RESOLUTION R-4731

A RESOLUTION OF THE CITY COUNCIL OF THE CITY OF KIRKLAND ADOPTING FINDINGS AND CONCLUSIONS GRANTING DESIGN REVIEW APPROVAL OF AN ALTERNATIVE DESIGN FOR THE BANK OF AMERICA/MERRILL GARDENS MIXED USE PROJECT AT 101 KIRKLAND AVENUE. (FILE NO.: DRC 07-0006; APPEAL CASE NO.: APL08-0001)

EXHIBIT B**BEFORE THE KIRKLAND CITY COUNCIL**

5 Story Alternative 10.31.08

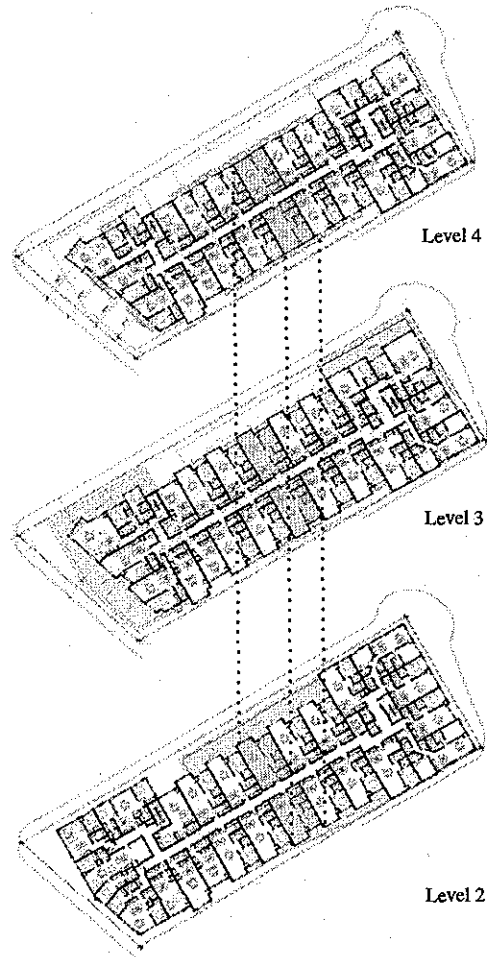
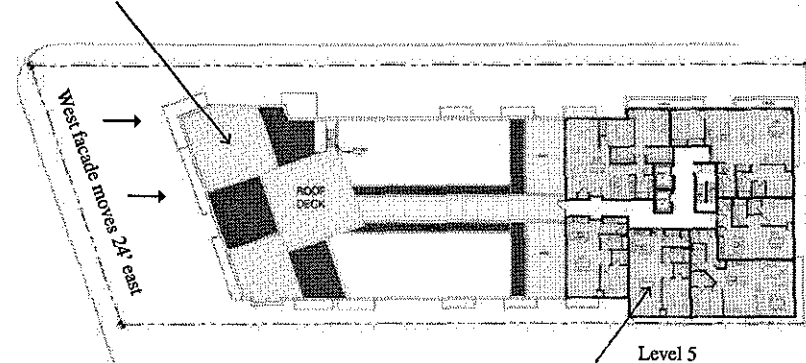
remove 6 units from the center
of the 4 story building

Re-establish roof top deck

relocate the 6 units to a small fifth level on the east building

The 5 story alternative is presented as a way of maintaining the economics of the building, yet providing significant pedestrian enhancements. By simply reallocating 6 units in the body of the 4 story building to a very small 5th floor, most of the west facade can be moved east by 24', the width of these units. This allows for a plaza 25% larger than what was approved by the DRB, restores an 35% larger cafe space onto Lake Street, and creates a lasting public amenity on one of the main corners of downtown Kirkland.

Plaza Square Footage

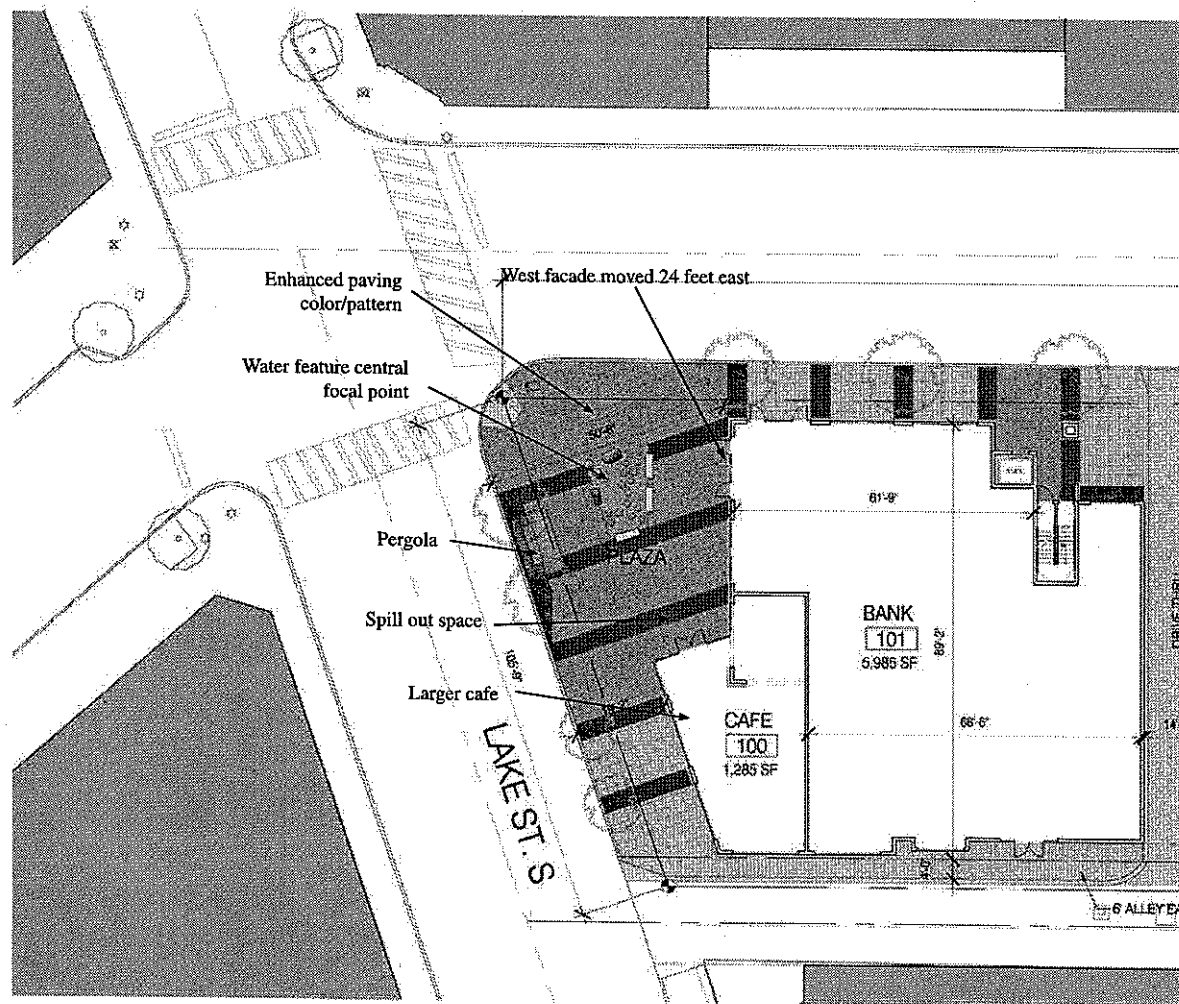
With the 5 story alternative the plaza is 25% larger than the original design and 50% larger than any of the settlement designs presented to date. The water feature is again the central feature and the cafe has a significant presence on the plaza with spill out space for tables and chairs. The sidewalk in front of the cafe is over 19' wide and the plaza opens up to nearly 50' on the north end. The pergola and enhanced paving remain.

Enlarged Plaza Features

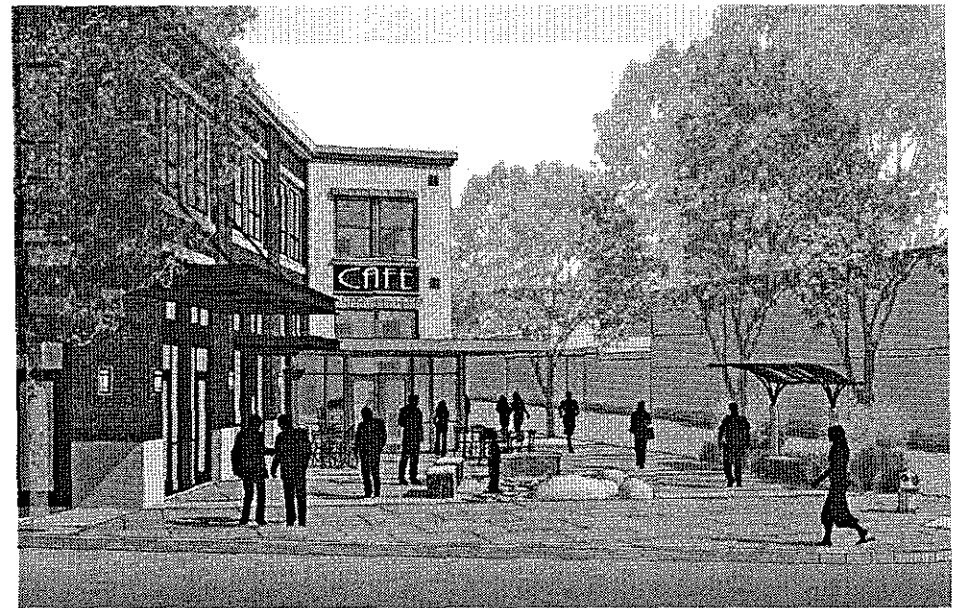
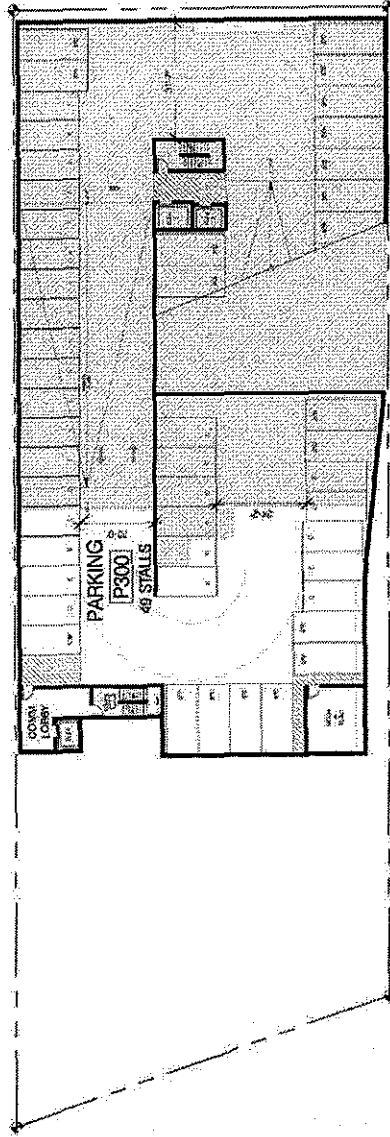
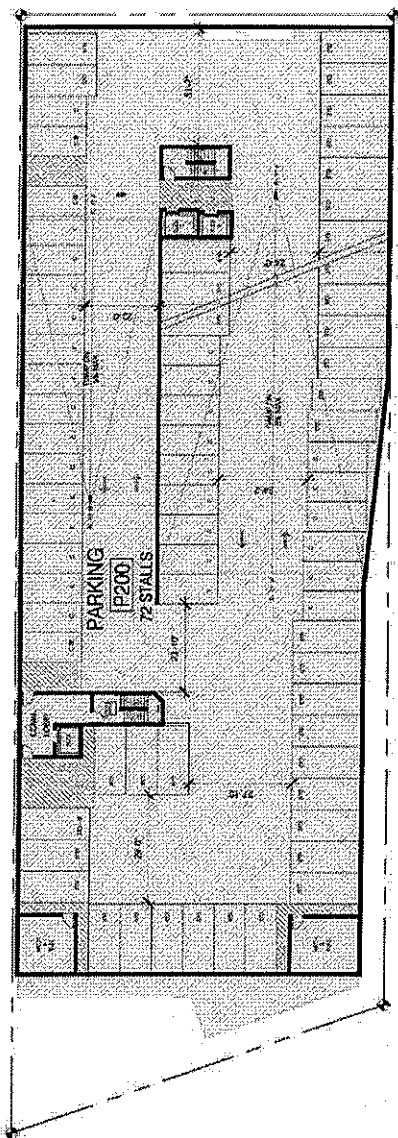
- Moved west facade east 24 feet
- 19' sidewalk in front of cafe
- Plaza 50' widest point
- Interactive water feature reinstated as central focal point
- Cafe has large presence on the plaza with spill out space for tables and chairs
- Pergola over east facing bench
- Enhanced paving with concrete banding and coloring in plaza area
- Roof deck reinstated providing activity at multiple levels along Lake St.

Aerial View of 5 story alternative

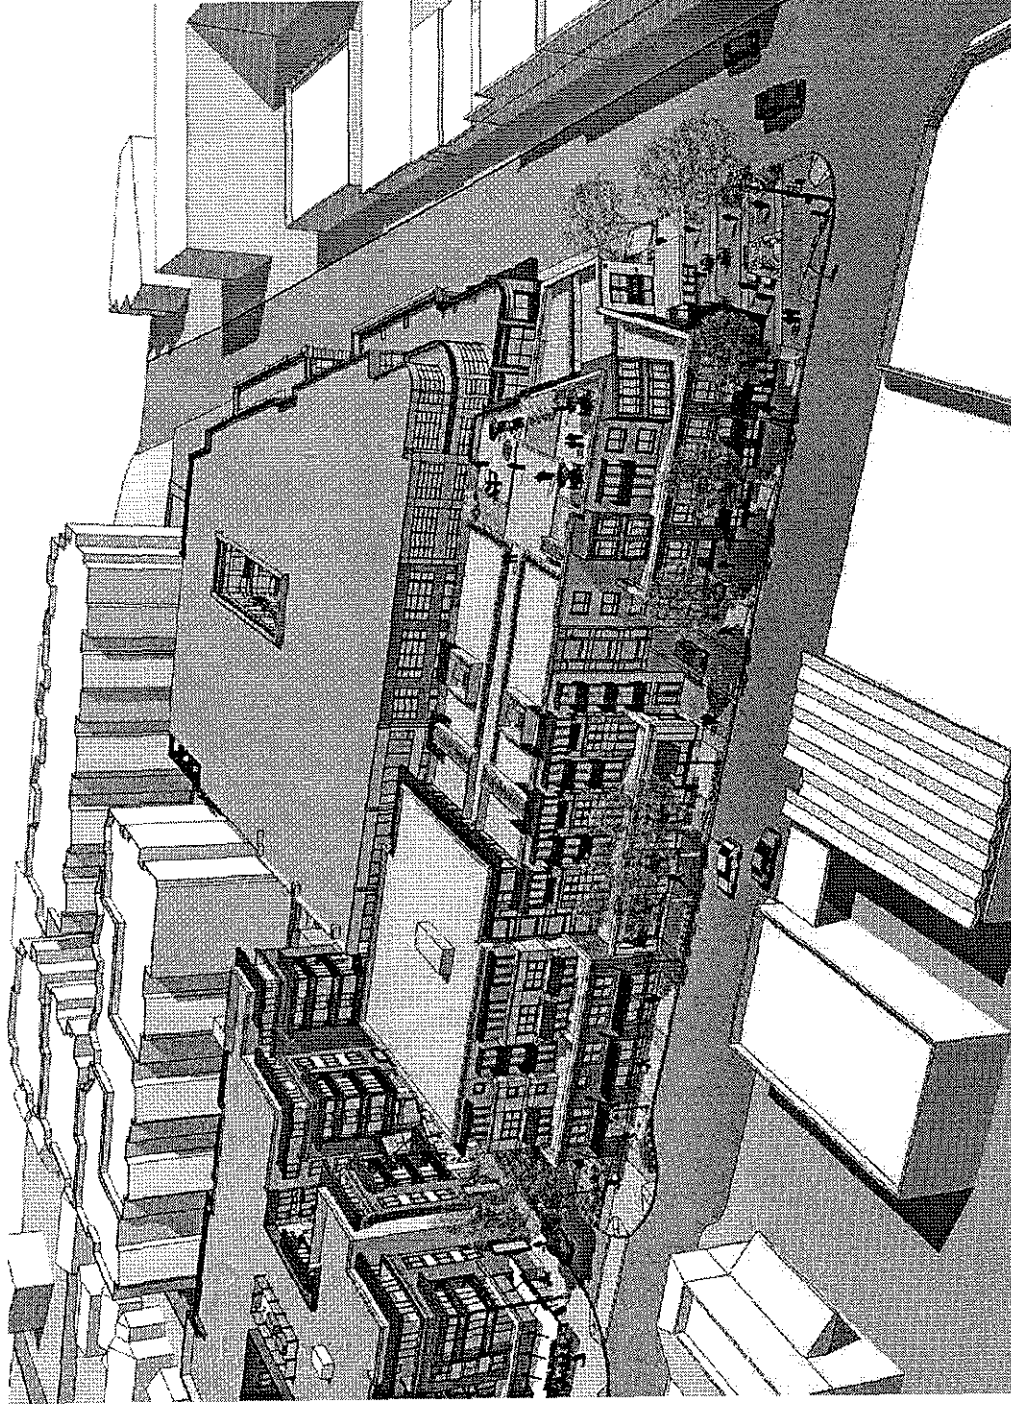
3.19 The stories above the second story of the project are set back significantly from the street and south of Kirkland Avenue the building form is stepped back at the third, fourth, and fifth stories to mitigate building mass. *Alternative Design Plans at page E.1.*

3.20 The proposed Project building form steps up from the north and west with the tallest portion at the easternmost part of the structure, and when considered against other existing and approved structures on adjacent and nearby parcels, the building forms step up from the north and west with the tallest portions located at the base of the hillside to help moderate the mass of large buildings on top of the bluff. *Alternative Design Plans at page E.1.*
